SERVICE BULLETIN

PRODUCT: Computer Monitor
BULLETIN: MON 97-004
MODEL: CFX1577L

SUBJECT: Vertical Positioning Shifted Off Center

Figure 1

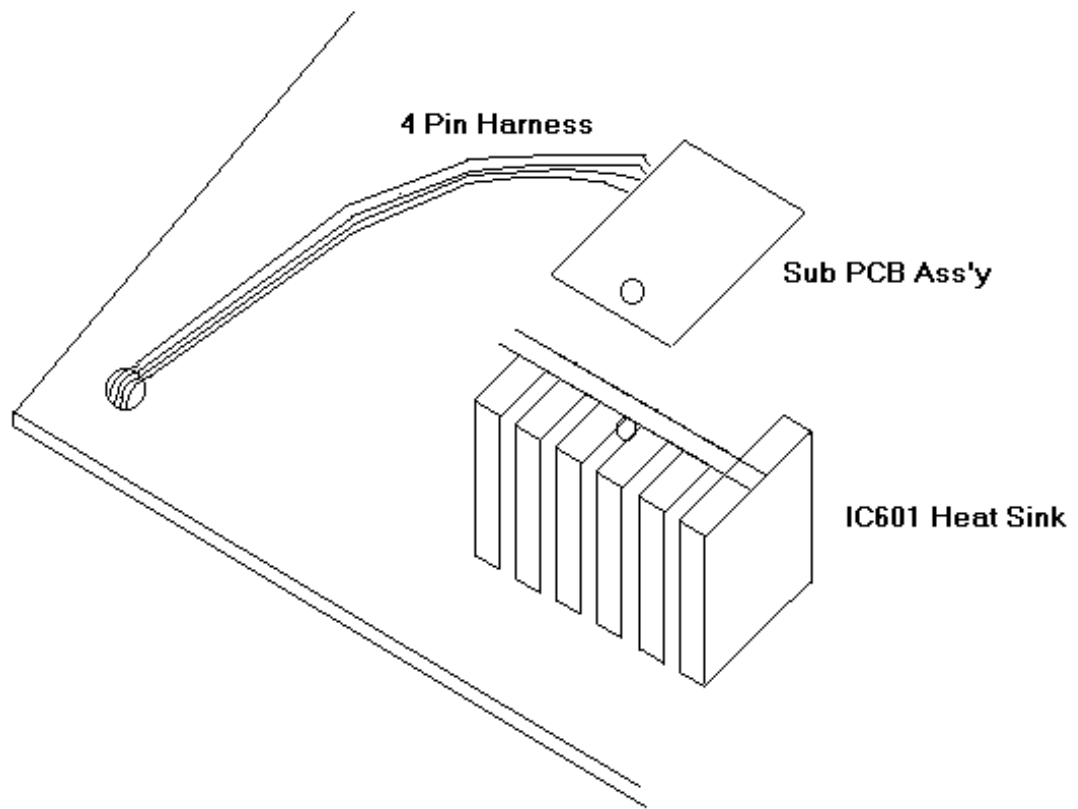
SUBJECT: Q407 Failure Causing No Raster or Small Horizontal Size

BACKGROUND: Q407 fails due to a transient pulse and current when mode switching from DOS to Windows. This occurs with a Matrox video card installed in the computer.

SOLUTION: Add a sub-PCB assembly as in figures 1 and 2 and a snubbing circuit for the horizontal output as in figure 3.

ORIGINAL			NEW	
Location No.	Part No.	Description	Part No.	Description
NA	NA	NA	BH92-50106J	SUB-PCB ASSEMBLY
NA	NA	NA	BH39-40355S	4 PIN CBF-HARNESS
NA	NA	NA	6003-000129	TAPTITE SCREW
NA	NA	NA	0401-000005	1N4148 DIODE
NA	NA	NA	0402-000012	UF4007 DIODE
NA	NA	NA	2003-000009	220 OMHS, 1 WATT
